PRODUCT ADVISORY NOTICE

Subject: 62F Termination Change

Bulletin #1357

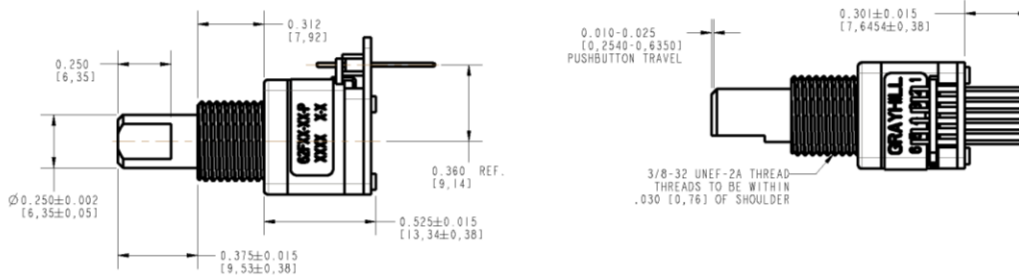
The pin header termination currently used on the 62F series is no longer available. Because of this, Grayhill will be changing the header used on this series to the Samtec MTMS-106-54-F-S-335. The change to the alternate header will result in a dimensional change to the termination on the encoder as shown in the image below.
